From: Oswald, Hank
Sent: Friday, January 7, 2022 9:21 AM
To: John Carney (jcarney@bei-civilengineering.com)
Subject: Revised Perc Cert Plan_2301 Woodbine Road_Spring Rock Farm Lot 1

PERCOLATION TEST
PLAT
**SPRING ROCK FARM
SUBDIVISION**
SECTION ONE - LOTS 1, 2, 3 & 4

From: Oswald, Hank
Sent: Thursday, March 31, 2022 12:03 PM
To: John Carney (jcarney@bei-civilengineering.com)
Subject: BAT Plan_2301 Woodbine Road
Attachments: LPD Design Manual.pdf

Re: 2301 Woodbine Road – Bat Site Plan Responses

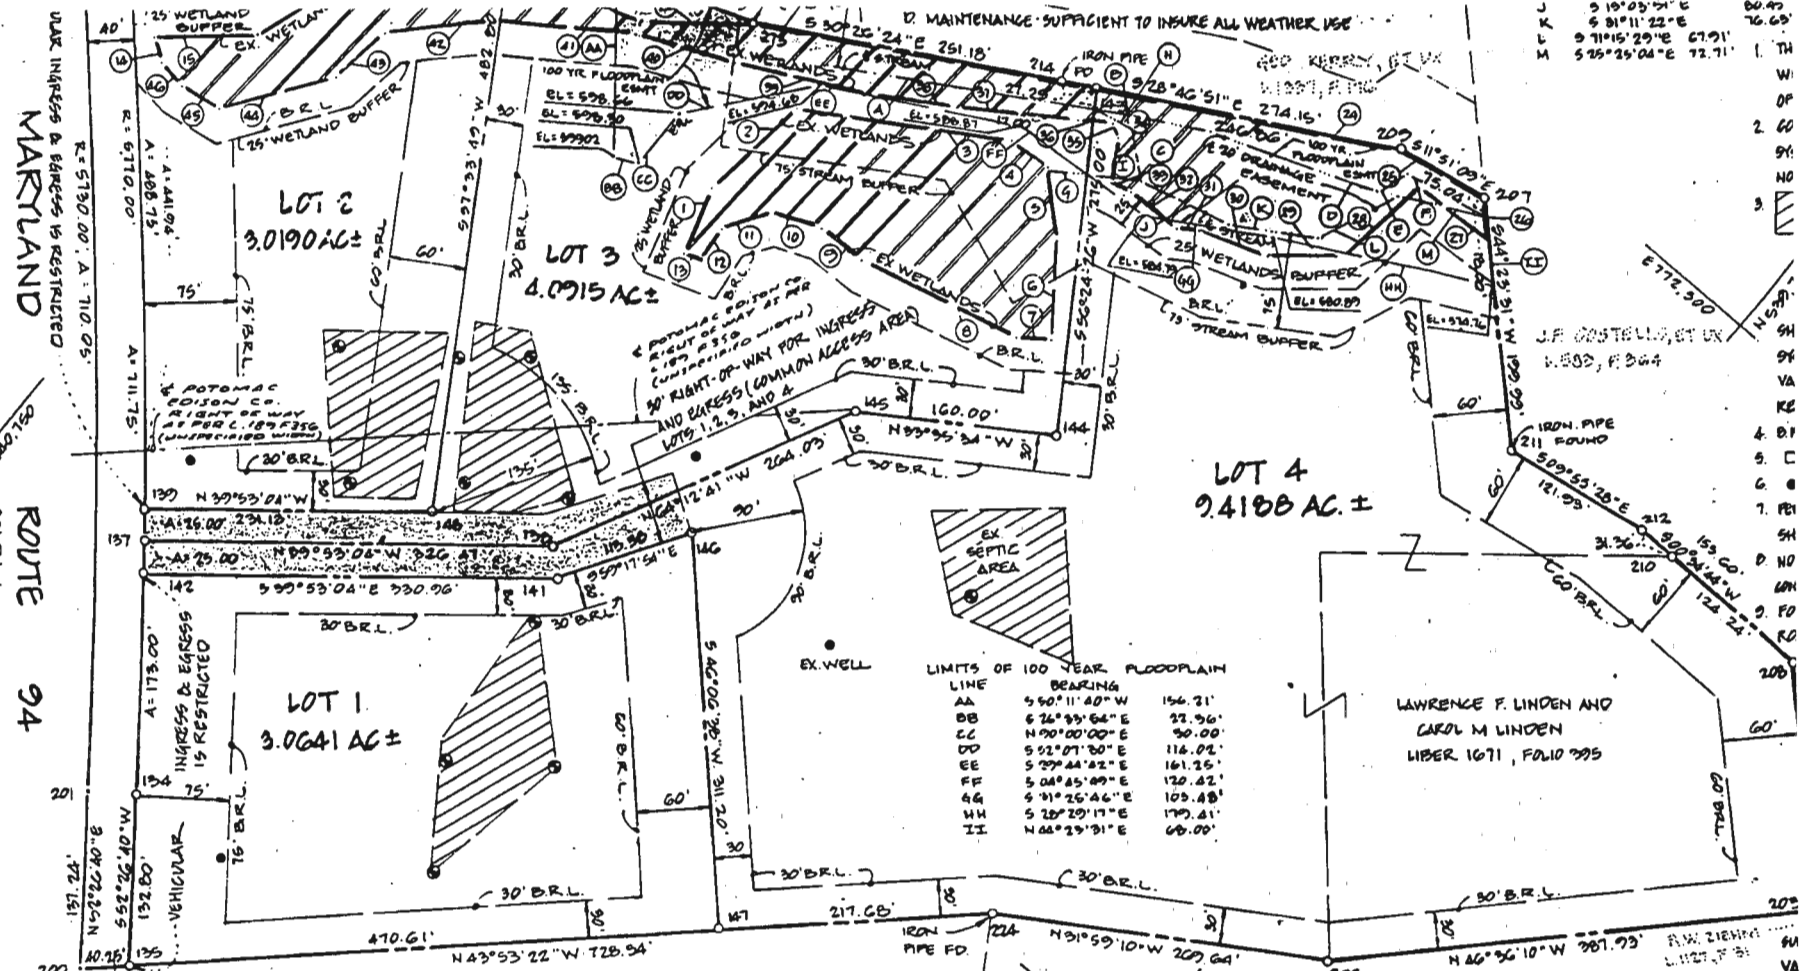
Good afternoon. The perc cert plan was kicked back with the following comment:

1. Change well label on plan for 2281 Woodbine Road to "Existing Well (no-tag) field located".

Hank, if you could make the change I would appreciate it. We just dropped off the BAT Site Plan earlier today. Client is anxious to get going. Thanks, John

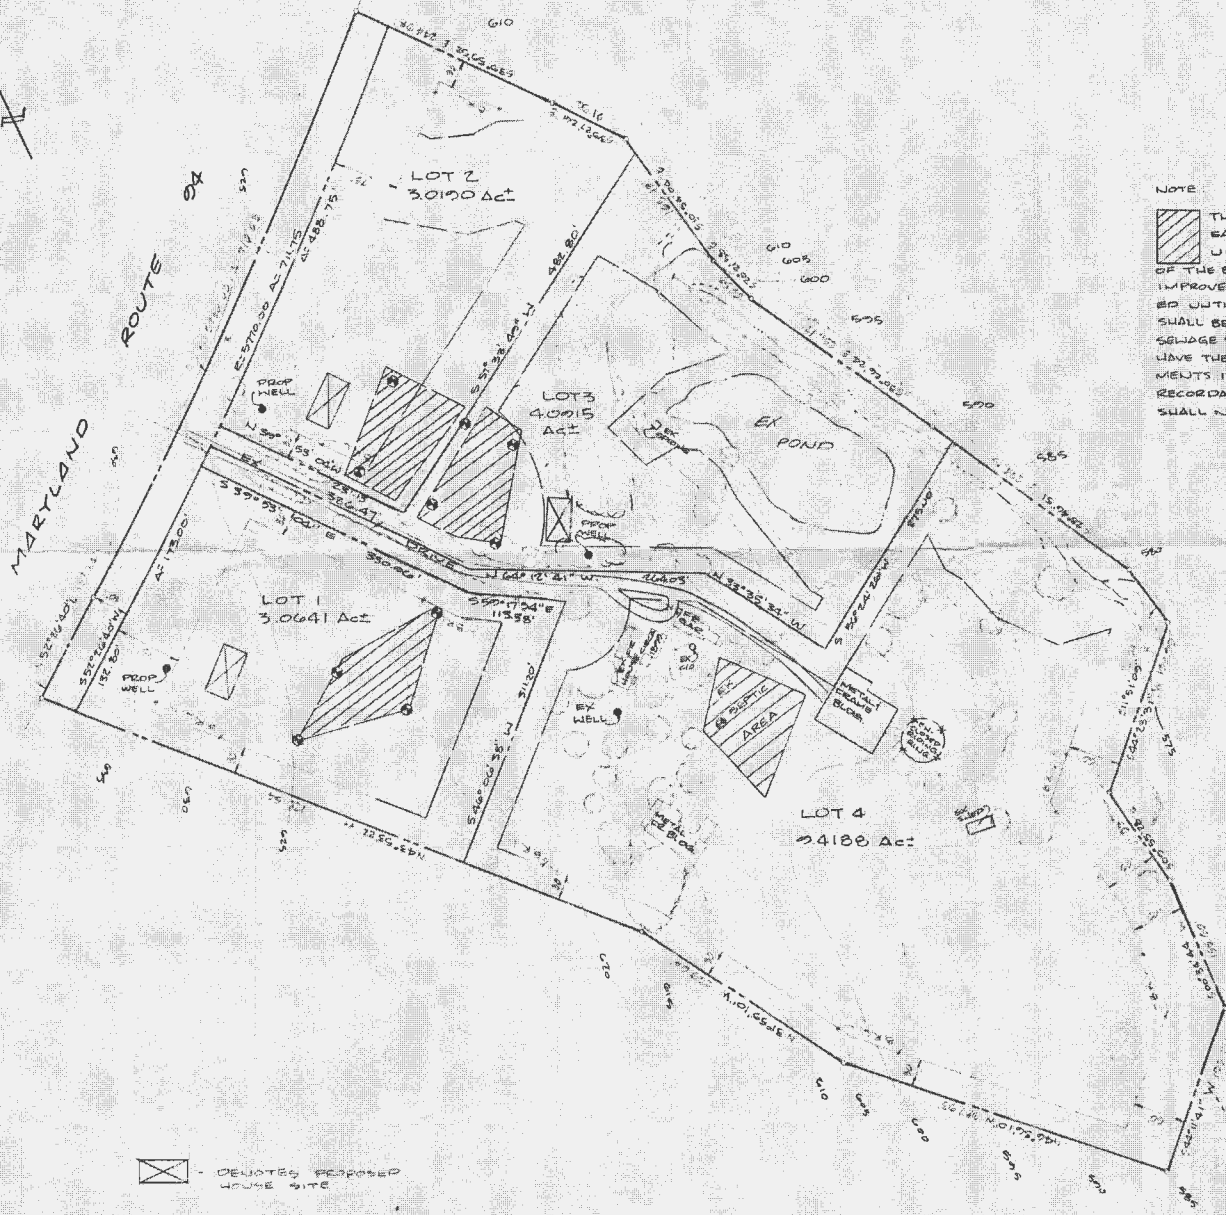
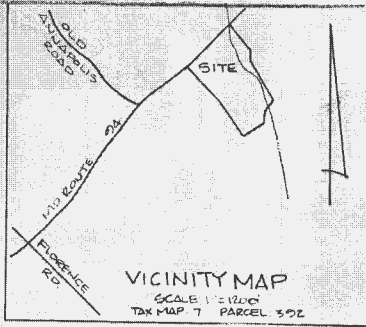
The revised perc cert plan for 2301 Woodbine Road (Spring Rock Farm Lot 1) has been reviewed with the following comments:

1. In addition to the variance request for the well box on this lot (lot 1), the owners will also need to request a variance for the down grade wells on lots 3 (2261 Woodbine Road) & 4 (2281 Woodbine Road).
2. Show a 200 foot well radius around each neighboring well on lots 3 and 4 and exclude any SDA on lot 1 within that 200 ft radius.
3. Please submit revision with variance request application to the Health Department for MDE review.
